## Addendum No. 01

November 21, 2017

San Francisco Unified School District  
Rooftop Burnett Elem. School  
443 Burnett Ave.  
San Francisco, CA 94131  
DSA File #38-1 Appl. #01-116865

PROJECT  
Rooftop Burnett Elementary  
School - 2018 Relocatable  
Replacement

REF SHT	REVISION	DWG
E1.1	1	AD1-E1.1

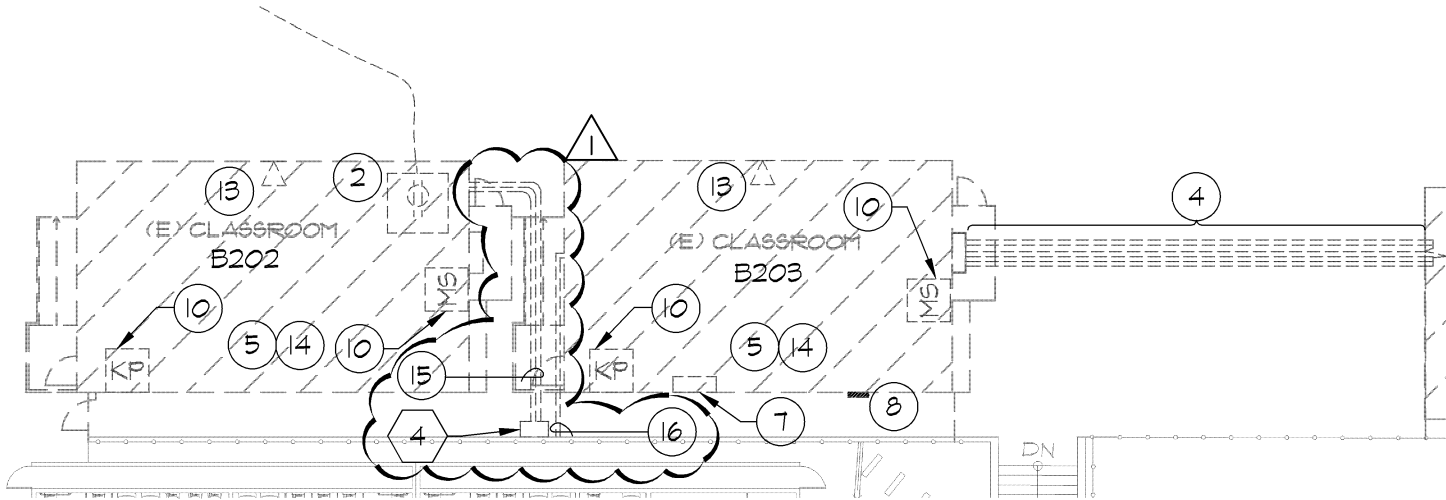
- b. Where conduits are removed from existing pull cans, the contractor is to provide and install a new aluminum cover over the exposed holes in the pull can to provide a weather resistant cover. Seal as required. See attached sheet ADD1-E1.1 to clarify removal of existing conduit between (E) portables B202 and B203.

- 15 (E) CANOPY CONDUIT TO BE DEMOLISHED.
- 16 (E) CONDUIT TO BE DEMOLISHED. CAP CONDUIT AT ENTRANCE TO (E) MODULAR RESTROOM BUILDING.

- 4 (E) PULLCAN ON MODULAR BUILDING TO REMAIN. CONTRACTOR TO PATCH PULLCAN AS REQUIRED AFTER DEMO OF (E) CONDUITS.
